EAST ROSWELL LIBRARY
ADDENDUM NO. 04.1-3
APRIL 25, 2013

This Addendum No. 04.1-3 dated April 25, 2013 issued by Ajax Building Corporation of Georgia is hereby made part of Bid Package 04.1 – MASONRY for the East Roswell Library. The changes and/or clarifications included in this Addendum shall be considered as part of the Bidding Documents and shall supersede, amend, add to, or subtract from those conditions included in the original Bidding Documents, including the Project Bid Package, Drawings, Specifications, previous Addenda, etc. This Addendum must be acknowledged in the space provided on the Proposal Form (included in Section II of the Bid Package). Failure to acknowledge this Addendum may subject Bidder to disqualification.

PRE-BID REQUEST FOR INFORMATION ("RFI")

Receiver's Reply:
Piedmont Pipe Downspout - Model SO

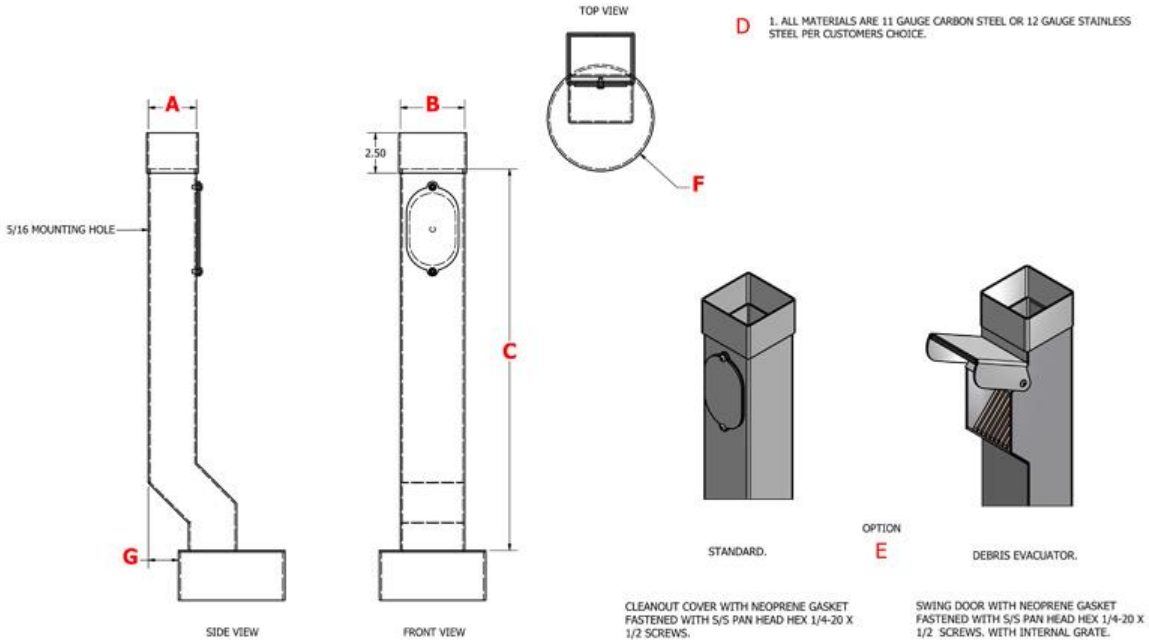
Job Id: 201209 **Name:** East Roswell Library	**RFI No.** 006 **Reference:** 2/A5.70, A3.10 **Issue Date:** **04/23/2013** **Requested by:** **04/30/2013**
Issued To: Khafra Attn: John Ray 1601 5th Avenue, North Birmingham, AL 35203 jray@khafra.com	**Issued By:** Ajax Building Corporation Attn: Rebecca Bailey 5950 Shiloh Road East, Suite S Alpharetta, GA 30005 rebecca@ajaxbuilding.com

Please provide Body Length and Offset Size for downspout boots.

A: To Receive 8" Diameter OD Downspout
B: To Receive 8" Diameter OD Downspout
C: 24"
D: 304 Carbon Steel with Manufacturer's standard black finish
E: Standard Cleanout
F: To connect to 8" Storm drain
G: 4" off set
